### DESIGN CHANGES ADDRESSED

- ♦ Ground and Upper floor mullion spacing
- ♦ Cantilevered slab finish
- ♦ Change of column and roof wall finish
- ♦ Redesign of Garage level bulkhead
- ♦ New Landscaping added
- ♦ Breezeway ceiling

STREET VIEW

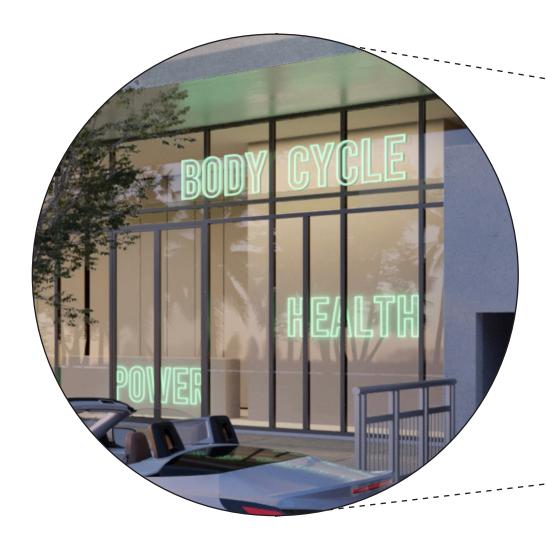
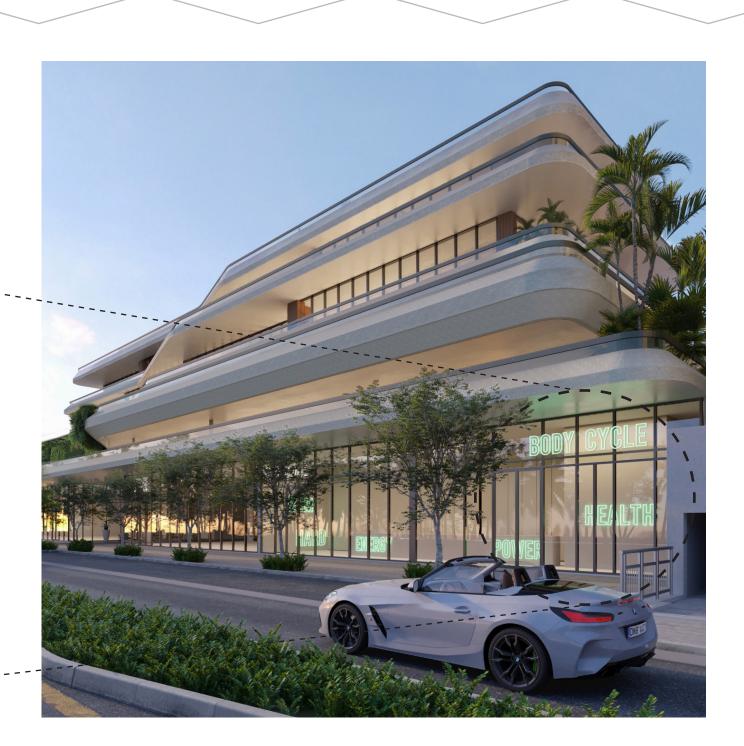
Mullion spacing was increased to a 4' spacing on the Ground floor and 5' spacing on Upper floors 3, 4 and 5.

4'-0" MULLION SPACING AT COMMERCIAL GLAZING STOREFRONT

5'-0" MULLION SPACING AT UPPER LEVEL GLAZING

**ELEVATION - NORTH**

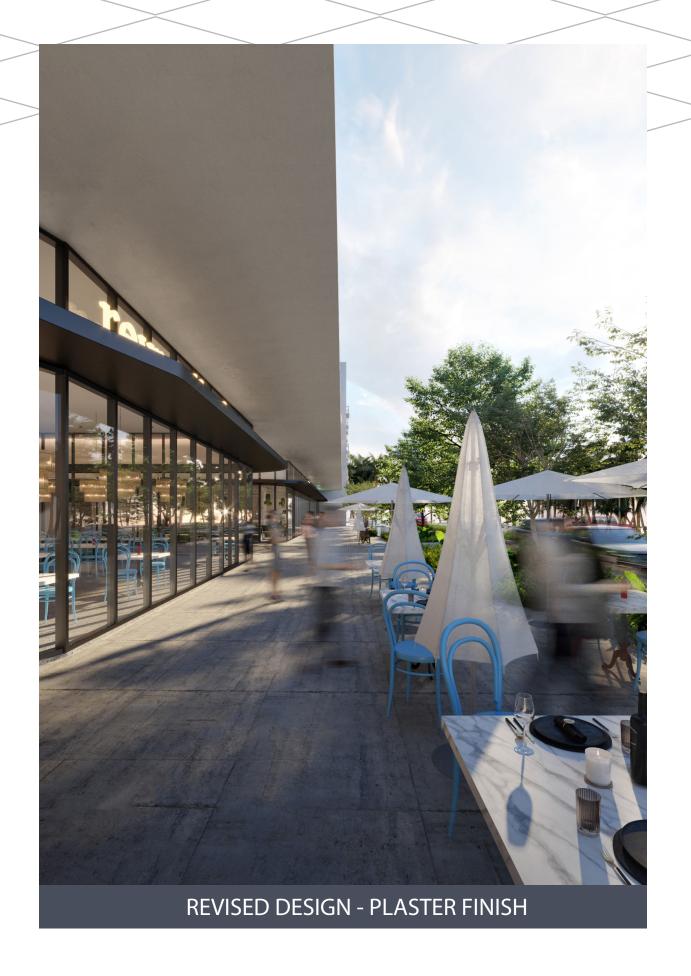
Cantilevered slab with plaster finish.

All exposed concrete columns on Upper floors 3, 4 and 5, as well as all roof level walls enclosing the elevator core and service rooms, will be cladded in IPE wood.

REVISED BULKHEAD DESIGN

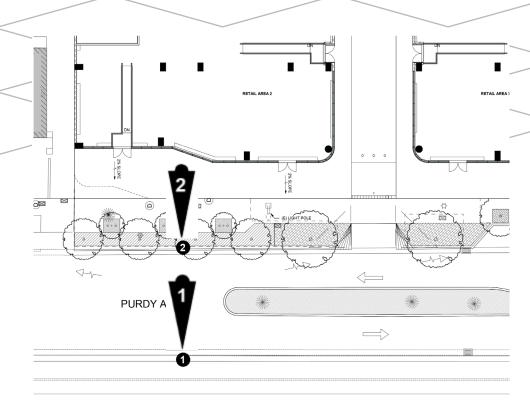
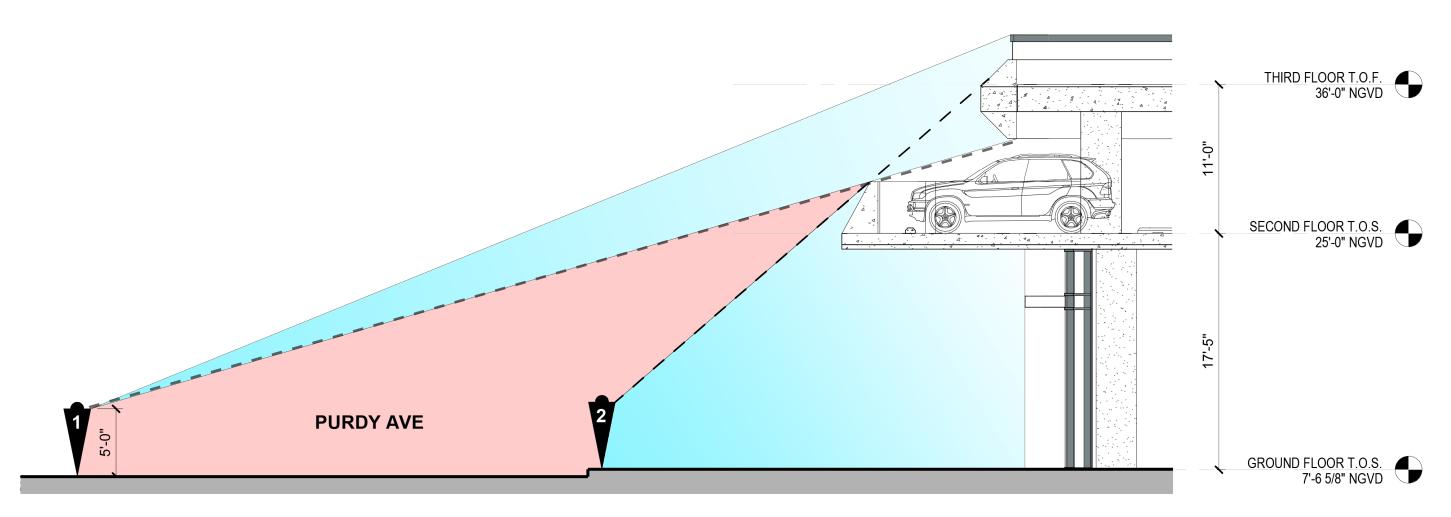
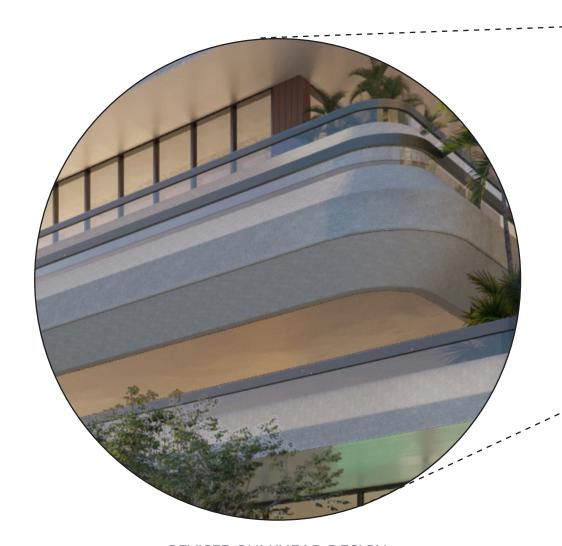
Garage level bulkhead was increased to 3'-6" above the finished floor in order to block vehicles lights and also block any exposed pipes in the garage, which could be seen from the pedestrian sidewalks below.

ROOF LANDSCAPE

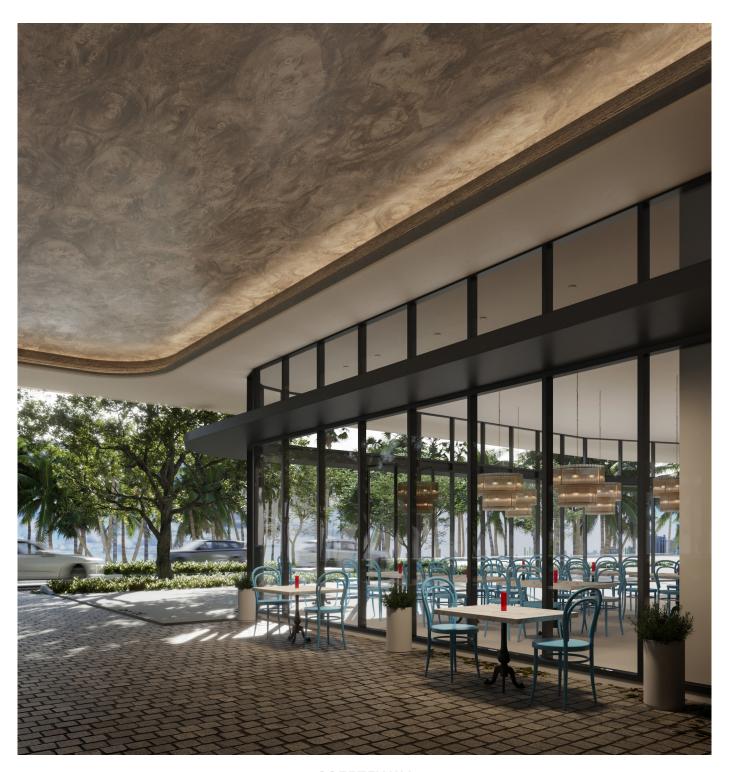
Additional landscaping has been added to the different levels of the building in order to soften the mass of the building and bulkhead railings.
